EXPANSION & RENOVATE AS NEW – PHASE 1

**CRYSTAL LAKE ELEMENTARY SCHOOL
284 SANDY BEACH ROAD
ELLINGTON, CT 06029
STATE PROJECT NO. 048-0058 EA/RR/PS**

DATE: January 3, 2013

The following changes to the Drawings and Project Specifications shall become a part of the Drawings and Project Specifications; superseding previously issued Drawings and Project Specifications to the extent modified by Addendum No. 4.

Drawing Number:
BIDDING PHASE
SKP2

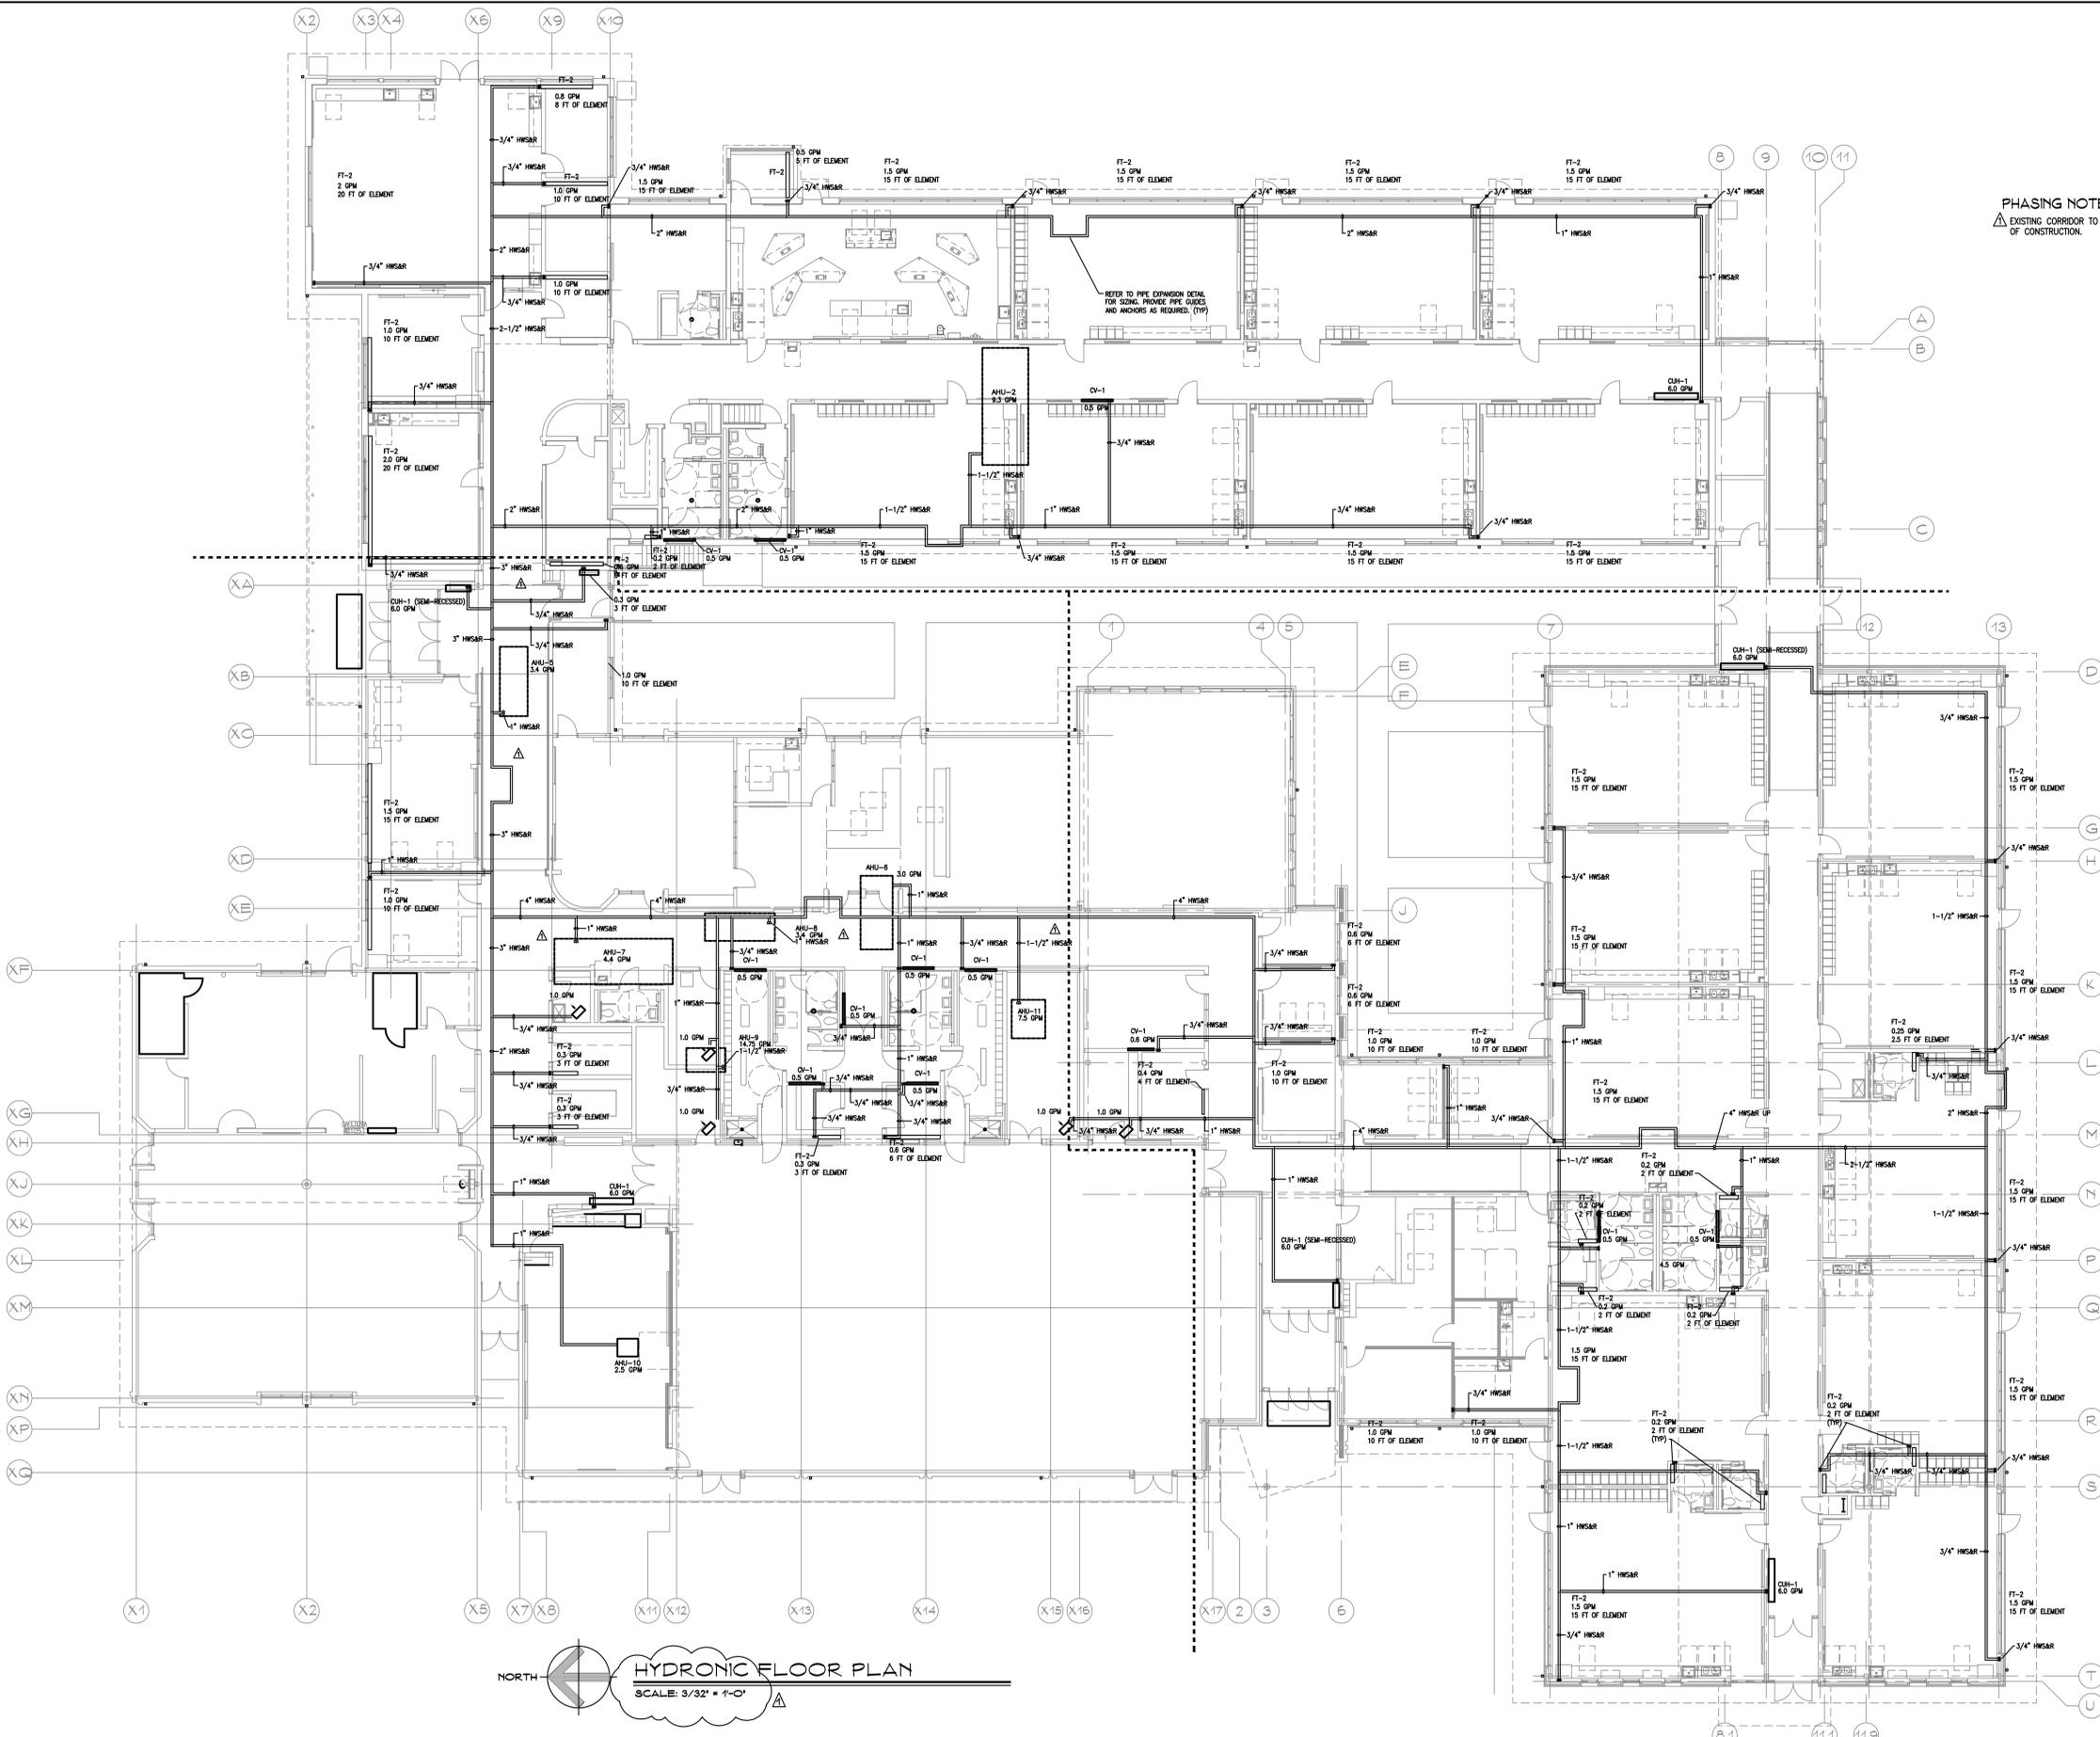
- DRAWING SKP2, PROVIDE BASEMENT FLOOR WATER DETECTION SYSTEM has been added and is attached as part of this addendum. This sketch revises information on Drawing P104.~

THIS SKETCH MODIFIES A PORTION OF DRAWING P104

PROVIDE BASEMENT
FLOOR WATER
DETECTION SYSTEM
